**CITY OF LOMPOC
PLANNING COMMISSION STAFF REPORT**

RE: **Request For Alternative Mitigation, Amendment No. 2 to Burton Ranch Specific Plan, and Review of Addendum to the Final Environmental Impact Report (EIR) For the Burton Ranch Specific Plan (Planning Division File No. FEIR 02-01 /SP 04-01)**

**BURTON RANCH
SPECIFIC PLAN**

Figure 2-1

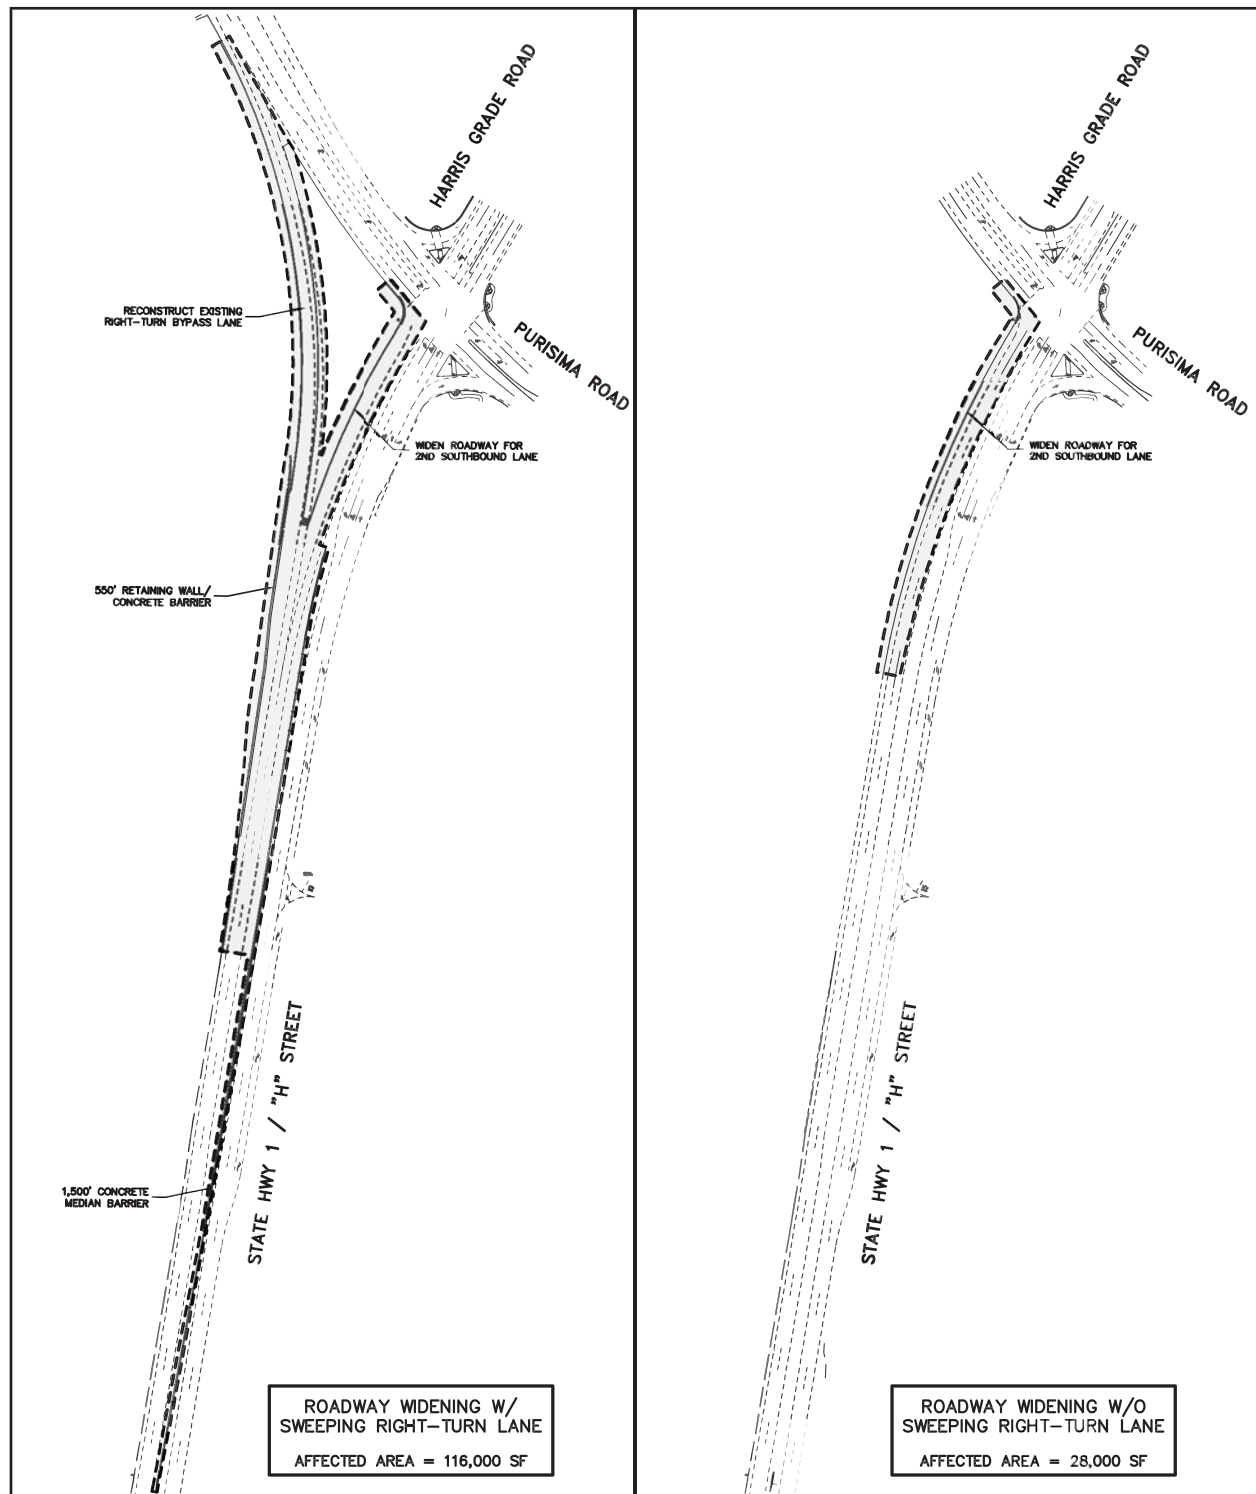
In addition, Mitigation Measure TRANS-1.2c is proposed for replacement in the EIR and Specific Plan with the following mitigation measure:

Figure 2-1 shows the difference in work area required by implementation of Mitigation Measure TRANS-1.2c with and without the presence of the eastbound to southbound sweeping right-turn lane. Following the review of the design of a second southbound lane and corresponding traffic analysis, Caltrans indicated that the substitute mitigation measure would be equally effective when compared to Mitigation Measure TRANS-1.2c.

- *Restripe of the northbound approach (dual left-turn lanes, one through lane and a right-turn lane), and;*
- *Provide traffic signal improvements to change the existing split phasing to protected left-turn phasing on the northbound and southbound approaches and to protected-permissive left-turn phasing on the eastbound and westbound approaches in conformance with the future operation assumed in the 2030 General Plan Update EIR."*

BUILDOUT+PROJECT VOLUMES
WITH IMPROVEMENTS

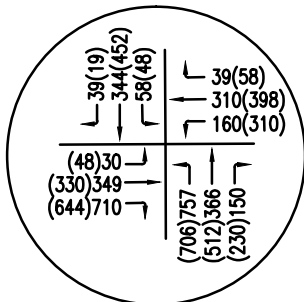
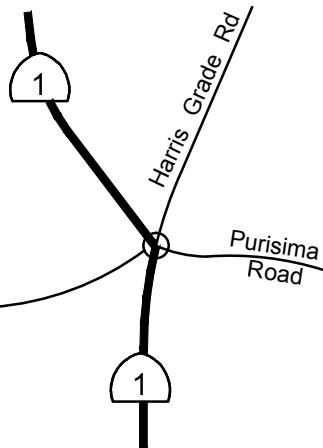
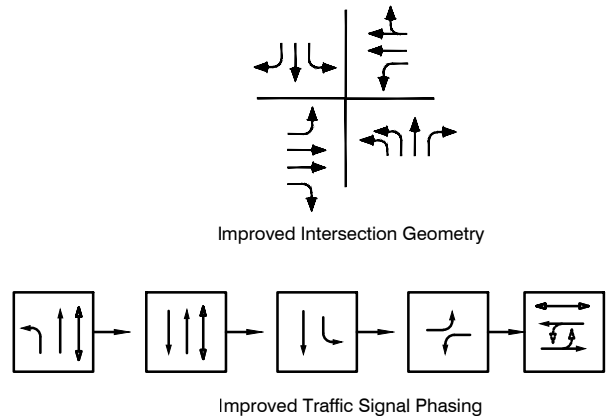
consistent with the methodologies used to calculate intersection levels of service in the *2030 General Plan Update EIR*. The revised project-specific and buildout traffic analyses for the Burton Ranch Project indicate that the State Route 1/Harris Grade Road intersection would operate at LOS C, under baseline plus project conditions with no improvements; and in the LOS C range under buildout plus project conditions with implementation of the following mitigations:

- Restripe of the northbound approach (dual left-turn lanes, one through lane and a right-turn lane), and;
- Traffic signal improvements to change the existing split phasing to protected left-turn phasing on the northbound and southbound approaches and to protected-permissive left-turn phasing on the eastbound and westbound approaches in conformance with the future operation assumed in the *2030 General Plan Update EIR*.
